RE: Application Number MP 10-0006 (Pindimar Abalone Project)

Record of Objection:

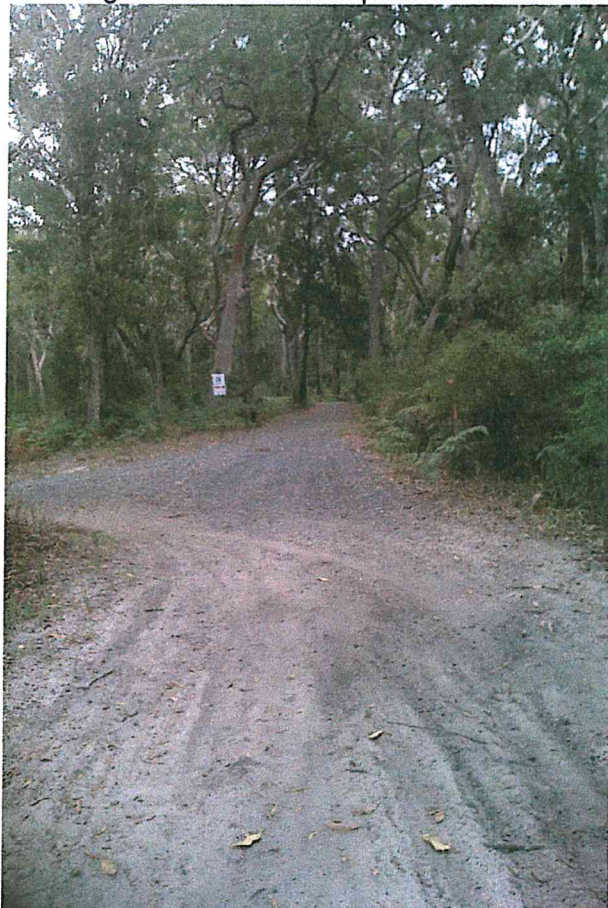
EAR Appendix 16 page 40 Oyster Farms : states "There are no operational oyster lease in near proximity" is misleading.

- There is an operating oyster lease right in front of Cambage Street homes that would be only 500 metres from the proposed development.
- I do not understand how the proponents reached their conclusion in Appendix 16 Aquatic Ecology Assessment that there are no operational oyster leases.
